Form 3160-5
(June 2015)

5. Lease Serial No. NMNM030453
6. If Indian, Allottee or Tribe Name
7. If Unit or CA/Agreement, Name and/or No. NMNM71016X
8. Well Name and No. POKER LAKE UNIT 13 DTD 903H
9. API Well No. 30-015-45845
10. Field and Pool or Exploratory Area PURPLE SAGE; WOLFCAMP
11. County or Parish, State EDDY COUNTY, NM

DRILLING PLAN: BLM COMPLIANCE
(Supplement to BLM 3160-3)

PECOS DISTRICT DRILLING CONDITIONS OF APPROVAL

10000# BOP

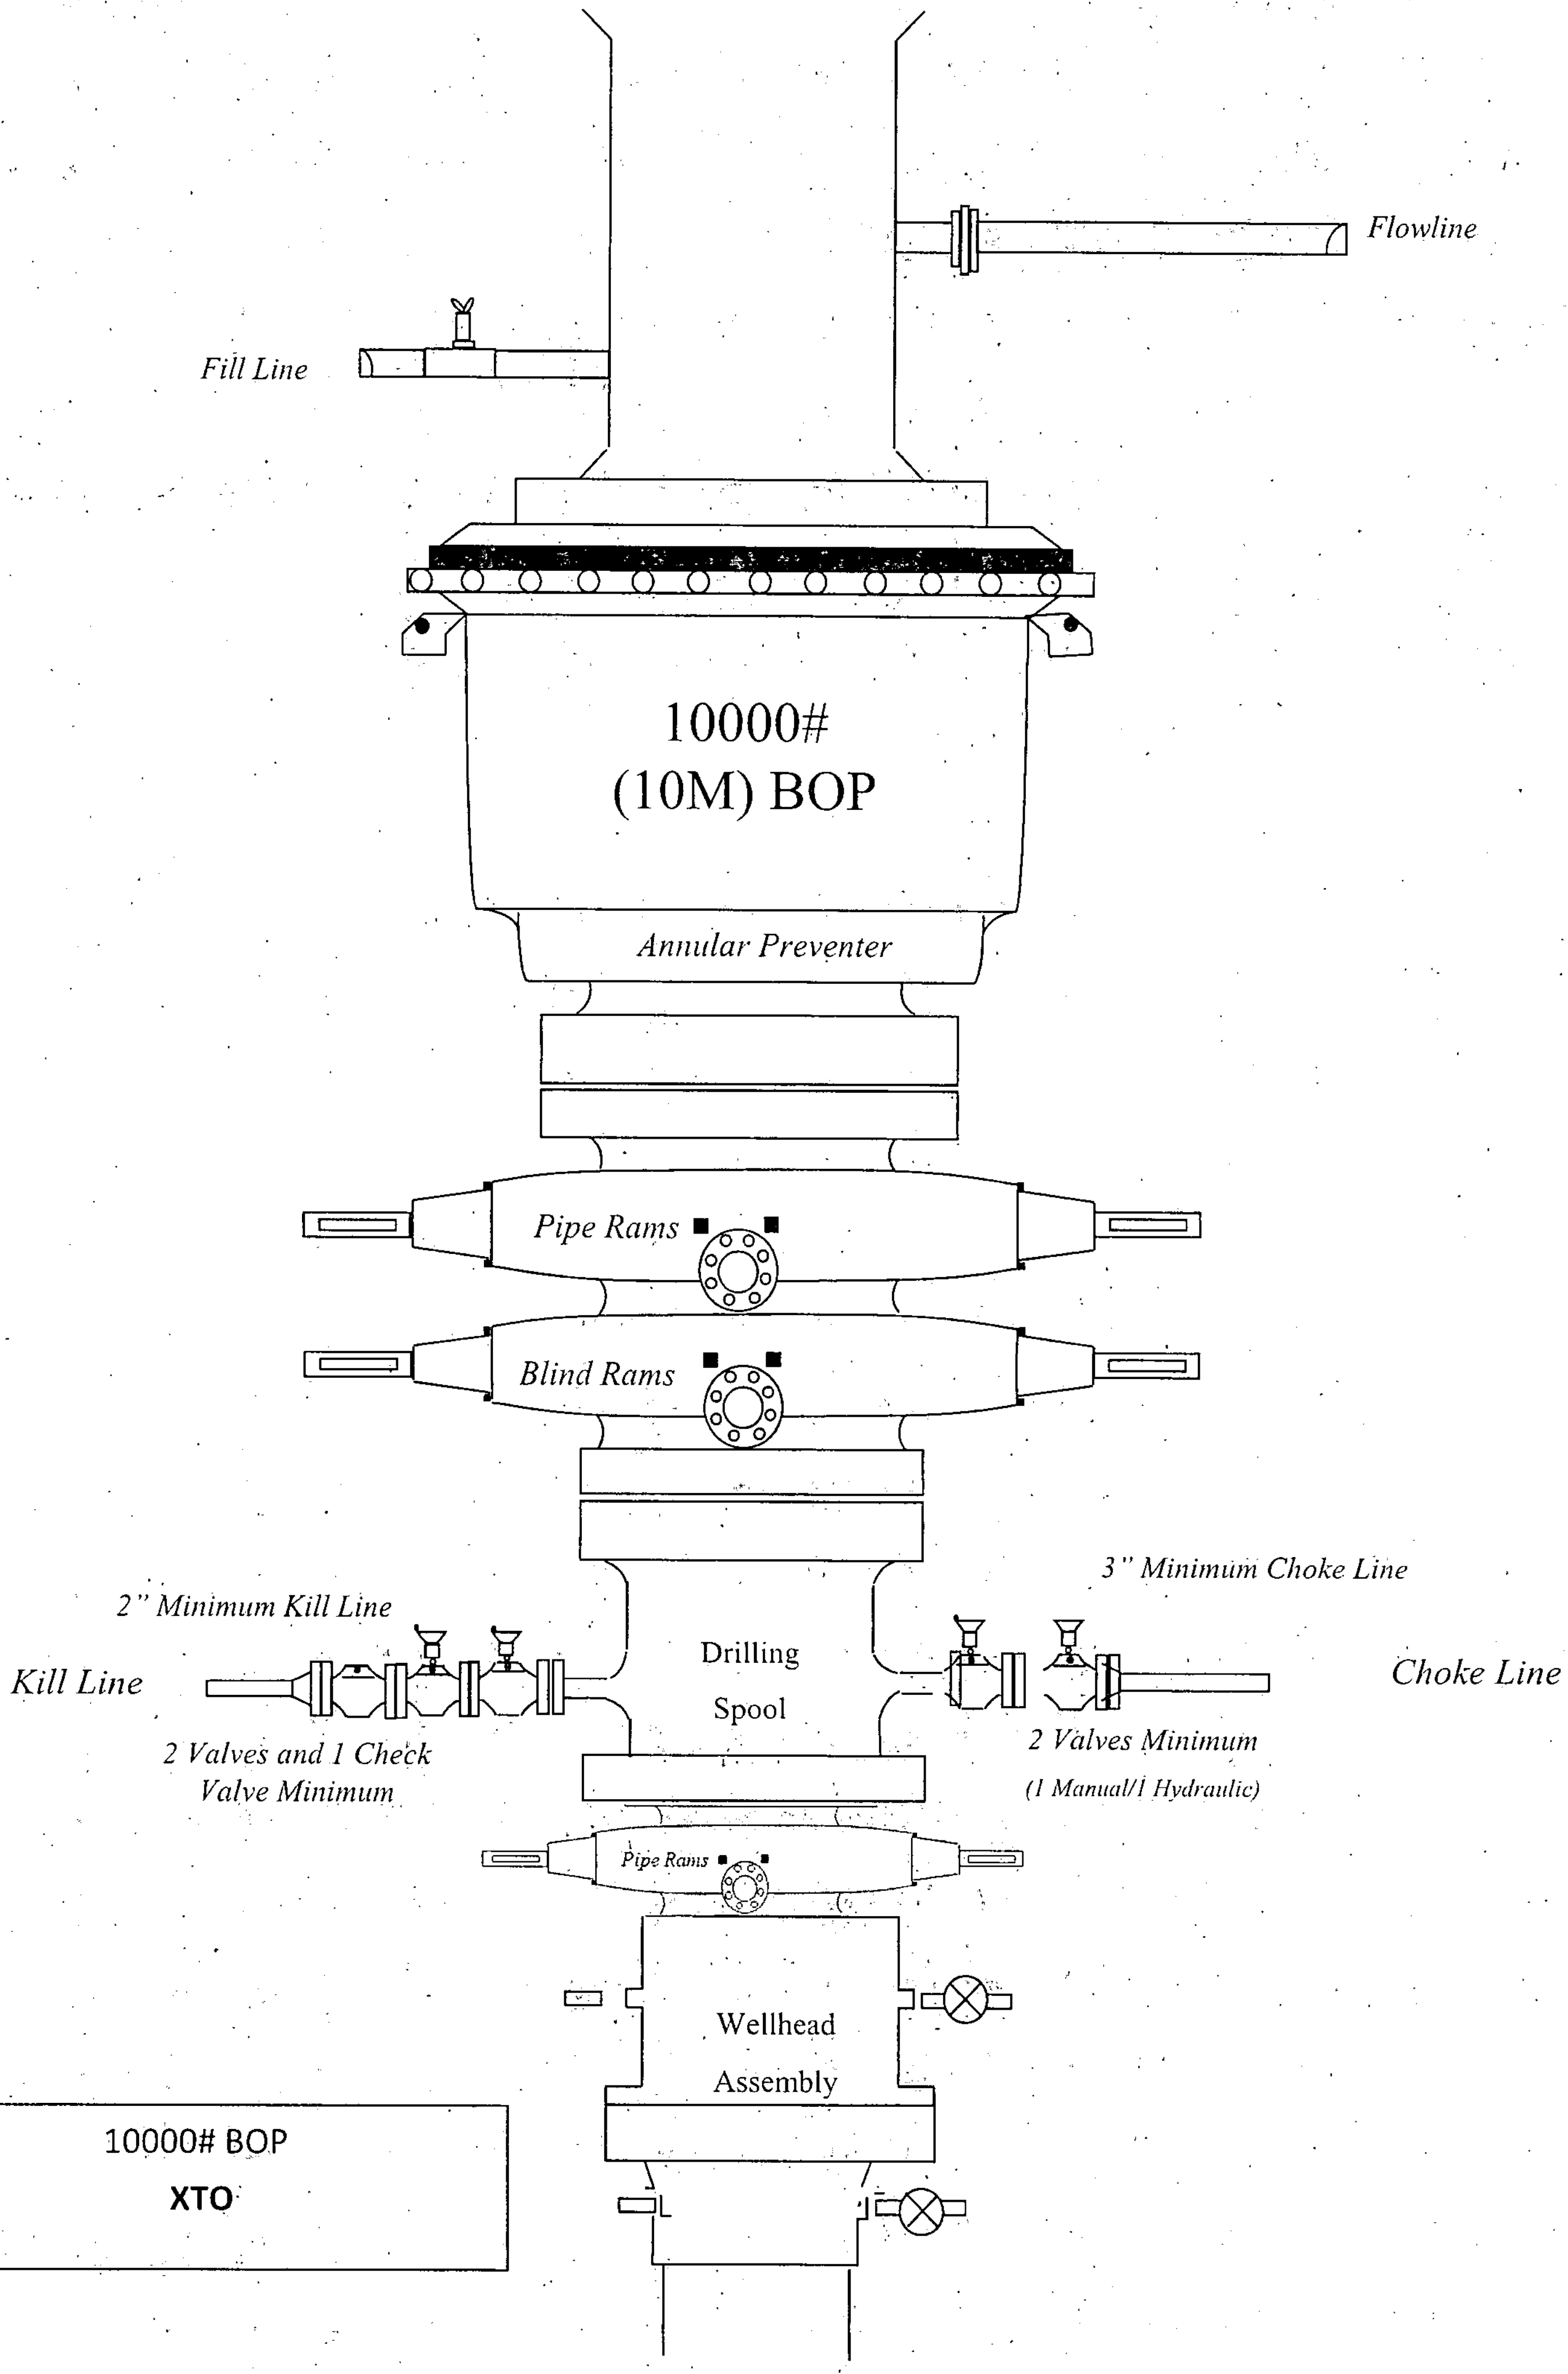
Once the perminent wellhead ~~is in~~stalled the blow out preventer equipment (BOP) for this well consists of a 13-5/8" minimum ~~5M~~ Hydril, and a 13-5/8" minimum ~~5M~~ Double Ram BOP. MASP should not exceed 4657 psi. See COA

10M needed

4. **Operator has proposed a multi-bowl wellhead assembly. This assembly will only be tested when installed on the 13-3/8" 1st intermediate casing. Minimum working pressure of the blowout preventer (BOP) and related equipment (BOPE) required for drilling below the 13-3/8" 1st intermediate casing shoe shall be 10,000 (10M) psi.**

10M system requires an HCR valve, remote kill line and annular to match. The remote kill line is to be installed prior to testing the system and tested to stack pressure.

Variance approved to use a 5M annular. The annular must be tested to full working pressure (5000 psi.)

11-14-16
XTO
Choke Line
#25
BR B 0-15000-5-H

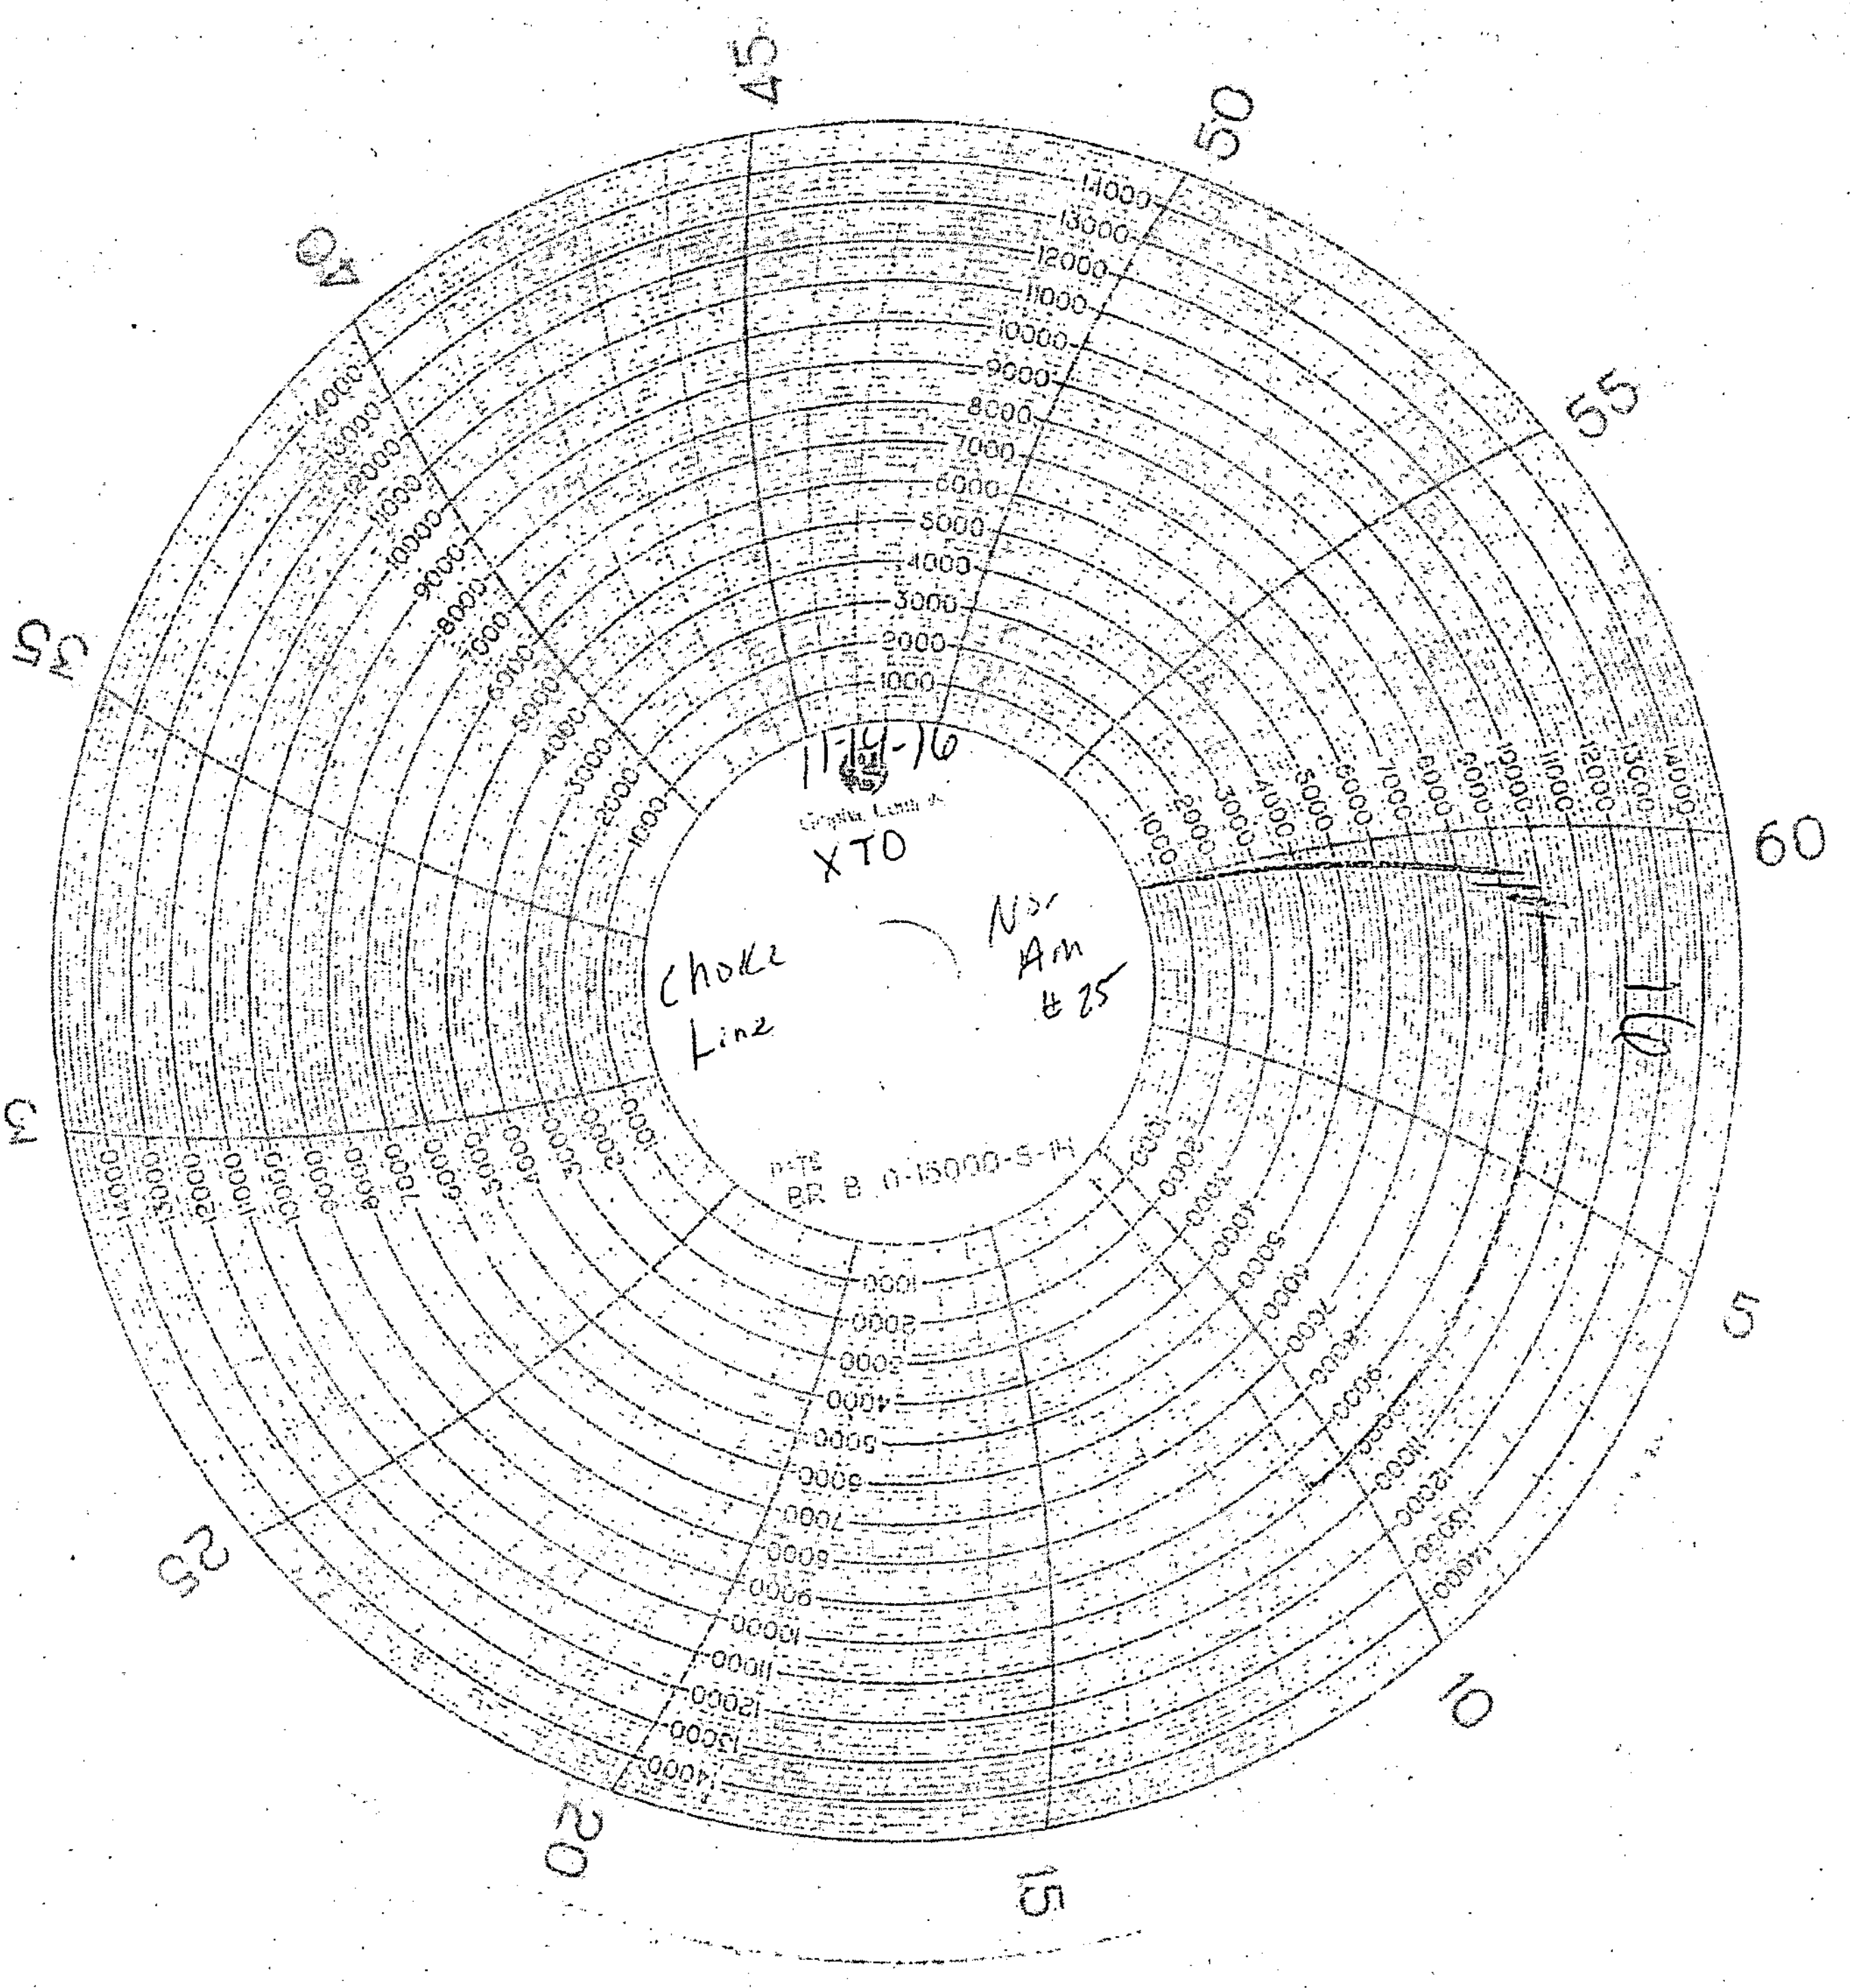
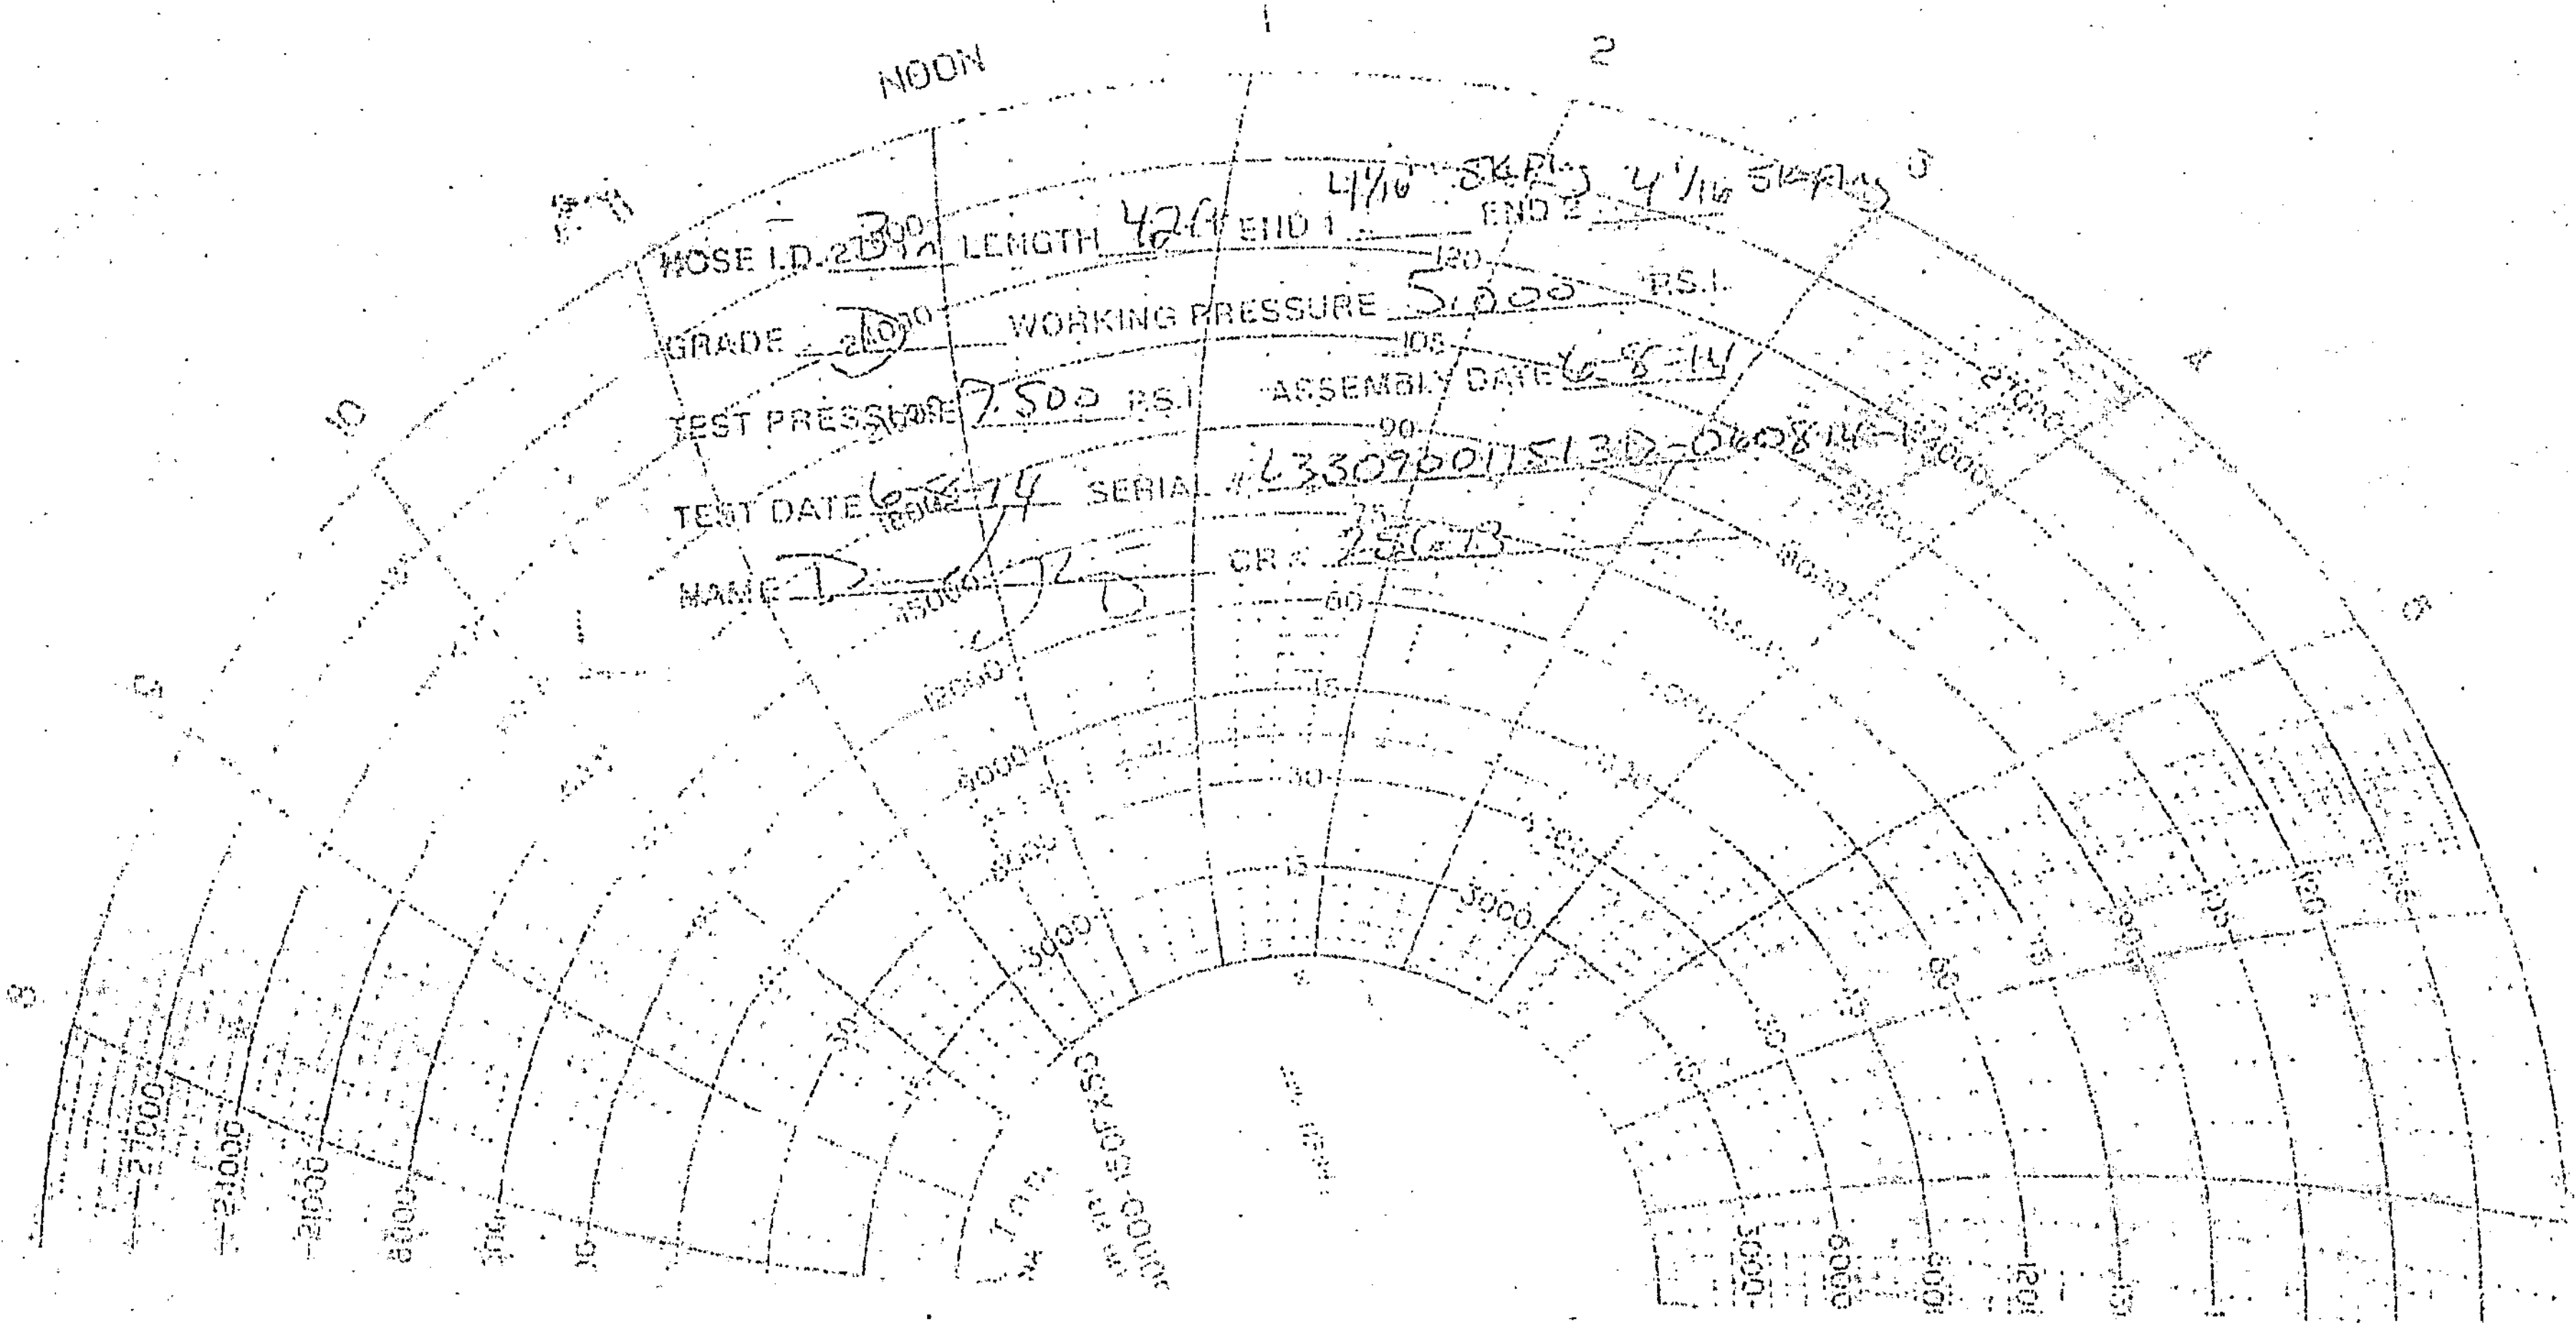
A variance is requested to allow use of a flex hose as the choke line from the BOP to the Choke Manifold. If this hose is used, a copy of the manufacturer's certification and pressure test chart will be kept on the rig. Attached is an example of a certification and pressure test chart. The manufacturer does not require anchors.

2. Variance approved to use flex line from BOP to choke manifold. Check condition of flexible line from BOP to choke manifold, replace if exterior is damaged or if line fails test. Line to be as straight as possible with no hard bends and is to be anchored according to Manufacturer's requirements. The flexible hose can be exchanged with a hose of equal size and equal or greater pressure rating. **Anchor requirements, specification sheet and hydrostatic pressure test certification matching the hose in service, to be onsite for review. These documents shall be posted in the company man's trailer and on the rig floor.** If the BLM inspector questions the straightness of the hose, a BLM engineer will be contacted and will review in the field or via picture supplied by inspector to determine if changes are required (operator shall expect delays if this occurs).
